BANCOR DEVELOPMENTS PTY LTD

TRAFFIC AND TRANSPORT  
INFORMATION FOR PREFERRED  
PROJECT REPORT IN RELATION  
TO PROPOSED MIXED USE  
DEVELOPMENT, 6 – 16 ATCHISON  
STREET, ST LEONARDS

APRIL 2011

REF: 8094/2

Existing morning peak hour traffic flows plus development traffic

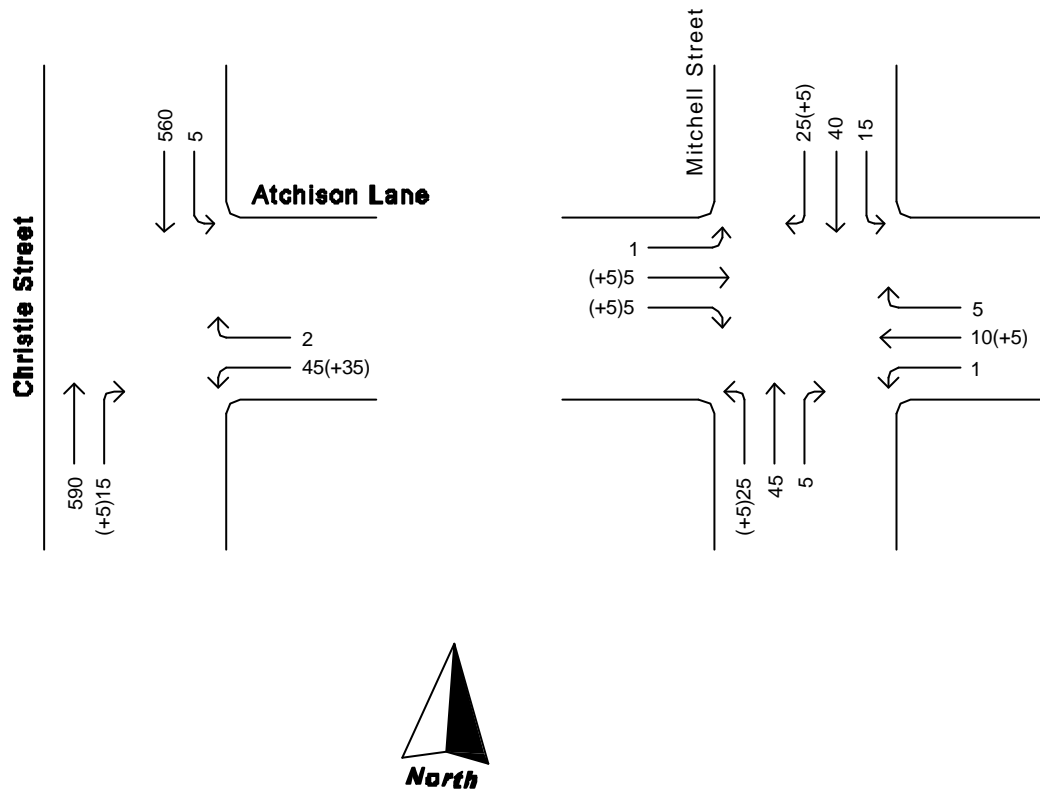
*A detailed assessment of traffic implications of the proposed development on the intersections of Atchison Lane/Christie Street and Atchison Lane/Mitchell Street should be provided.*

2.2 We have undertaken weekday morning and afternoon peak period intersection traffic counts at the intersections of Atchison Lane with Christie Street and Mitchell Street. Existing two-way peak hour traffic flows at these intersections are shown in Figures 2 and 3, and summarised in Table 2.1.

- 2.6 The SIDRA analysis found that the unsignalised intersections of Atchison Lane with Christie Street with Mitchell Street are operating with average delays for the highest delayed movements of less than 15 seconds per vehicle or less during morning and afternoon peak periods. This represents levels of service A/B, a good level of intersection operation.

- 2.7 The proposed amended development will result in an increase in traffic generation of some 55 to 65 vehicles per hour two-way during peak hours. These additional traffic flows are shown in Figures 2 and 3, and summarised in Table 2.2. Traffic increases in Atchison Lane would be some 15 to 45 vehicles per hour two-way at peak times as a result of the proposed development. Increases in Christie Street and Mitchell Street would be lower at some five to 40 vehicles per hour two-way.

- 2.8 The Atchison Lane intersections have been re-analysed with SIDRA for the additional development traffic flows shown in Figures 2 and 3. The analysis found that the Atchison Street intersections would continue to operate with average delays, for the highest delayed movements, of less than 15 seconds per vehicle during peak hours. This represents level of service A/B, a good level of service.
- 2.9 Copies of the SIDRA output summaries for the Atchison Lane intersections are attached as Appendix A.
- *Swept path analysis of the largest vehicle that can physically enter and exit Atchison Lane and the access driveway should be provided in accordance with the RTA's comments on the proposal.*
- 2.10 Vehicle swept paths are being prepared by URaP-TTW and provided under separate cover.

**Existing morning peak hour traffic flows plus St Leonards development traffic**

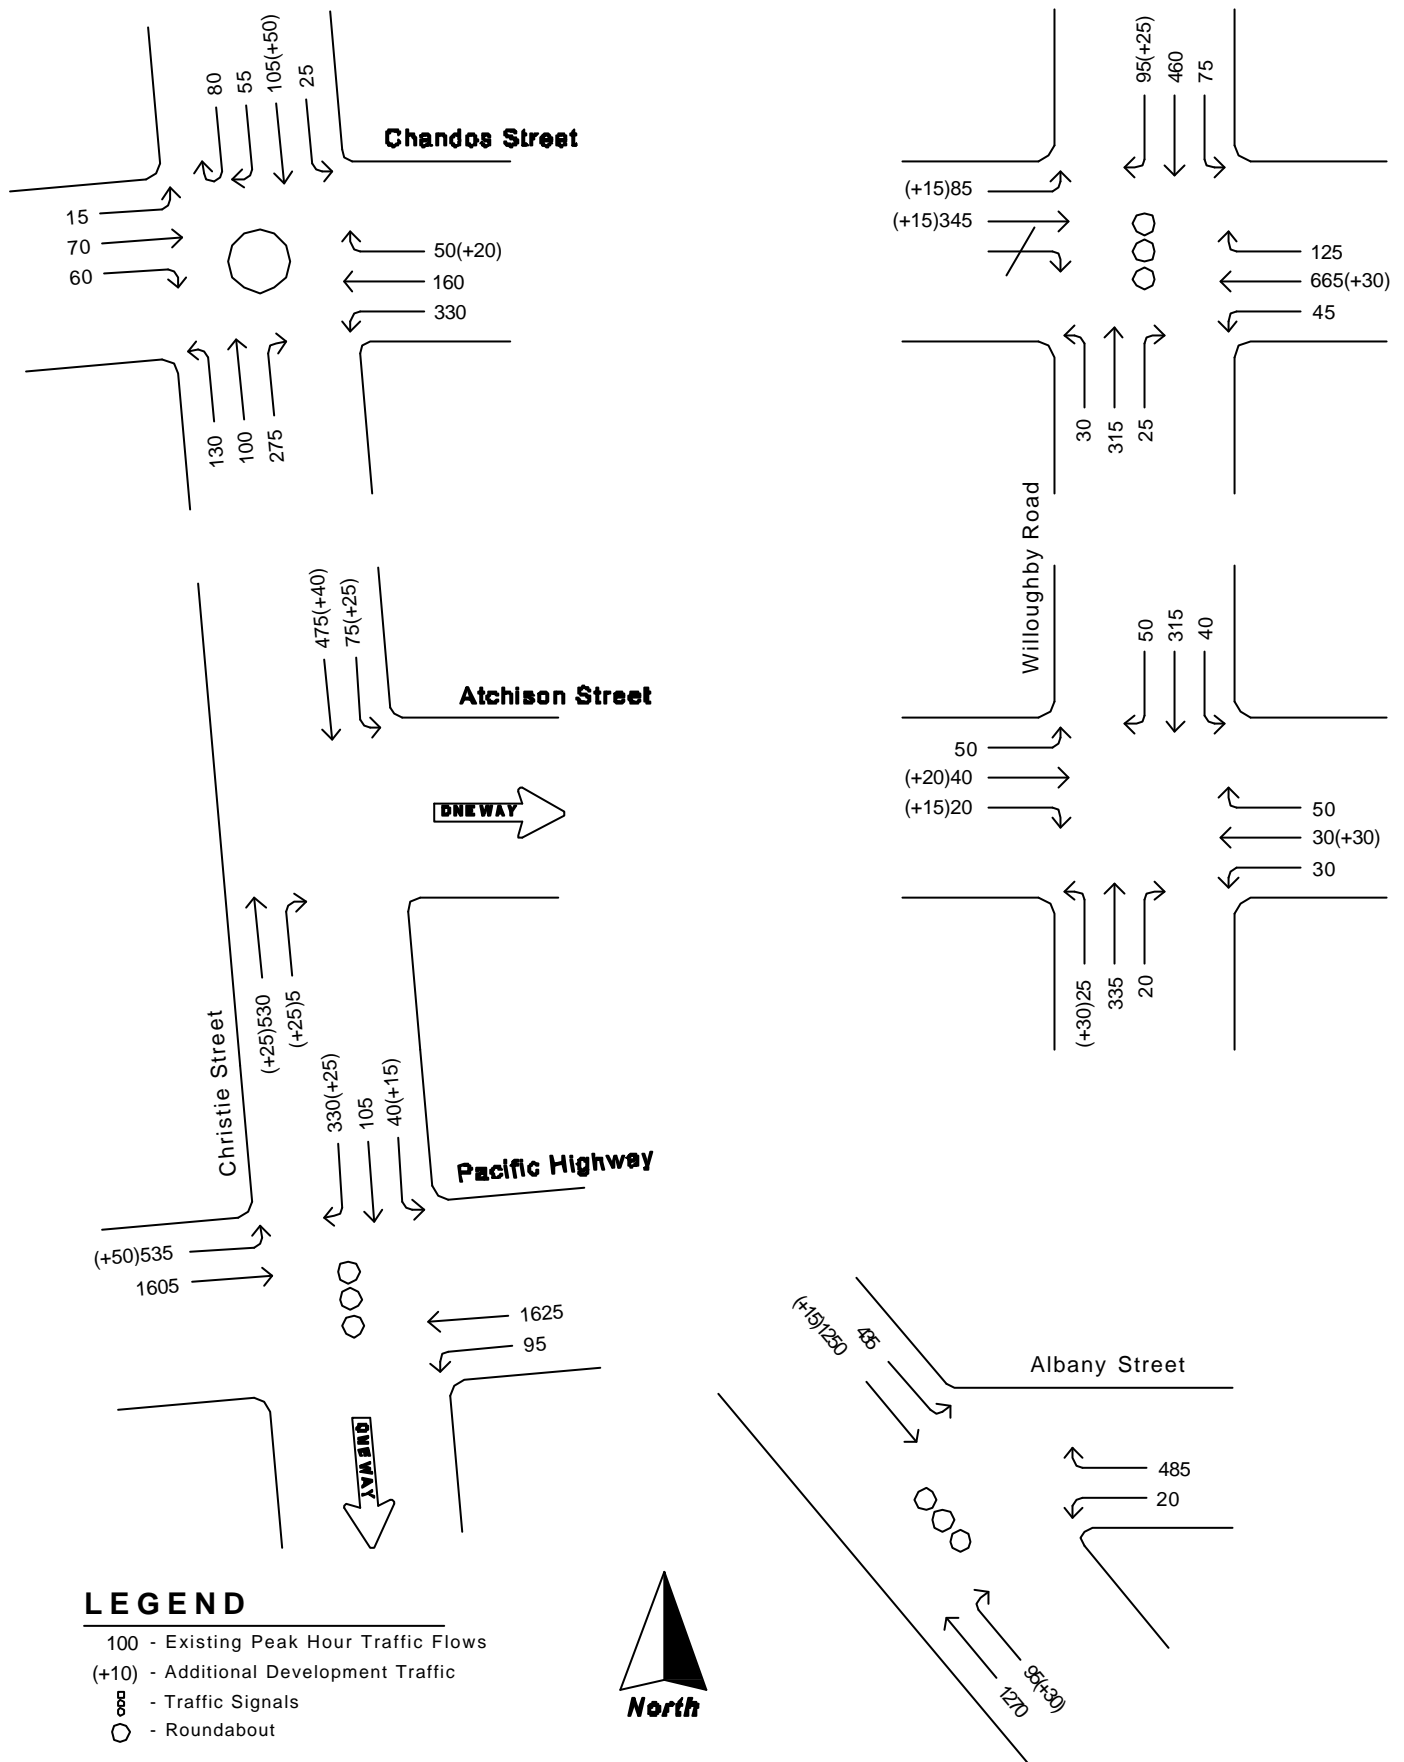
***...the cumulative impact of excessively large mixed use developments well in excess of the planning controls, such as this proposal, would have a significant impact on the local street system.***

2.40 The intersections in paragraph 2.37 have been analysed using SIDRA for the additional development traffic flows shown in Figures 4 and 5. The analysis found

that the intersections of Pacific Highway with Christie Street and Albany Street would operate with average delays of less than 35 seconds per vehicle during peak periods. This represents level of service C, a satisfactory level of service.

- 2.41 The intersections of Christie Street with Chandos Street and Atchison Street would operate with average delays of less than 20 seconds per vehicle during peak periods. This represents level of service B, a reasonable level of service.
- 2.42 The intersection of Willoughby Road with Chandos Street would operate with average delays of less than 35 seconds per vehicle during peak periods. This represents level of service C, a satisfactory level of service.
- 2.43 The intersection of Willoughby Road with Atchison Street would operate with average delays, for the highest delayed movement, of less than 25 seconds per vehicle during peak periods. This represents level of service B, a reasonable level of service.
- 2.44 Therefore, the road network will be able to cater for the additional traffic from the proposed development, as well as other development in St Leonards.
